City of El Paso – City Plan Commission Staff Report

Case No: SUSU12-00050 Haciendas Del Rio
Application Type: Major Combination
CPC Hearing Date: September 20, 2012
Staff Planner: Nathaniel Baker, (915) 541-4192, bakernt@elpasotexas.gov
Location: West of Doniphan Drive and South of La Union Avenue
Acreage: 91.8 acres
Rep District: West ETJ
Existing Use: Farmland
Existing Zoning: ETJ
Proposed Zoning: ETJ
Nearest Park: Mary Robbins Park (1.4 miles)
Nearest School: Child Development CE (0.4 miles)
Park Fees Required: N/A
Impact Fee Area: N/A
Property Owner: Haciendas Del Rio Partners LP
Applicant: Haciendas Del Rio Partners LP
Representative: CAD Consulting Company

APPLICATION DESCRIPTION

ATTACHMENT 3

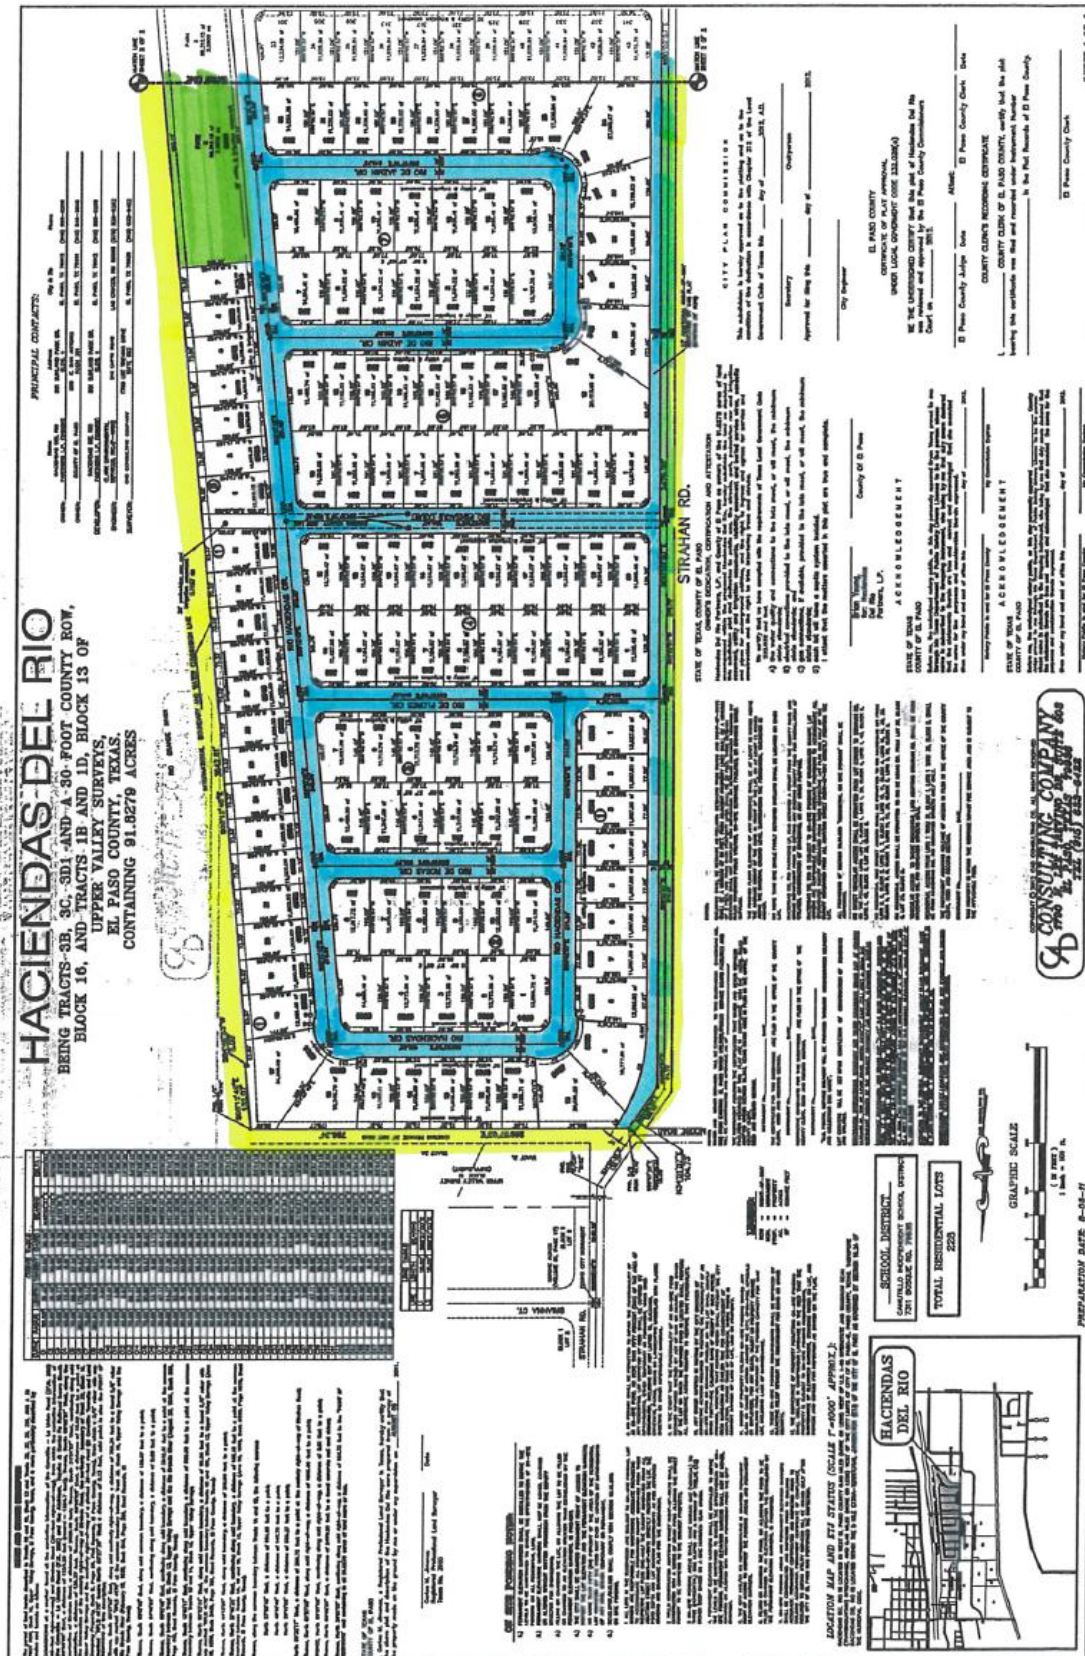
1. Vehicular access to Lot 37 Block 8 and Lot 23 Block 5 shall be from Rio Haciendas not Rio de Minas.
2. Add the following note: No structures exceeding 36 in. in height shall be located within the visibility easement located at Lot 37, Block 8
3. Developer shall provide traffic calming devices on Rio Haciendas Circle in accordance with the Amendment to the Development Agreement dated march 10, 2009; such traffic control shall be coordinated with El Paso Department of Transportation and reflected on the improvement plans for the subdivision.

1. Double frontage lots along Strahan and Moore shall comply with Section 19.16.080.D (Double frontage lots).
2. All existing/proposed paths of travel (accessible sidewalks, wheelchair access curb ramps and driveways) within public right-of-way shall be in accordance with the City Design Standards for Construction and be ADA/TAS compliant.

The Haciendas Del Rio Plat presented for this review increases the number of lots compared to the plat originally presented to EPWU-PSB by the Developer.

EPWU-PSB respectfully requests the Developer to submit the updates to Haciendas Del Rio to enable this office to update the water and sanitary sewer plans and Record information as per the new plat configuration.

EPWU-PSB respectfully requests the Developer to update the Final Engineering Report for Haciendas Del Rio to reflect the twenty-four (24) inch diameter sanitary sewer mains as well as the eighteen (18) inch diameter sanitary sewer mains being constructed by the Developer along Strahan Road.

1. The plat indicates on-site ponding will be used to manage stormwater runoff. To establish the feasibility of the proposed residential on-site ponding, the applicant shall submit hydraulic calculations prepared by a Professional Engineer as per Section 19.16.060C of the previous subdivision ordinance (March 11, 1997 – June 1, 2008). The submittal shall conform to the requirements outlined in Section J of the Drainage Plan Standard Detail of the City's Design Standards for Construction and the requirements outlined in Section 19.16.060C (1-7) of the previous subdivision ordinance. If on-site ponding as proposed is determined to be unfeasible, ponding in a common retention pond shall be required.

2. Provide the following on-site ponding requirements which reference the County of El Paso on the Preliminary Plat and the Final Plat sheets.
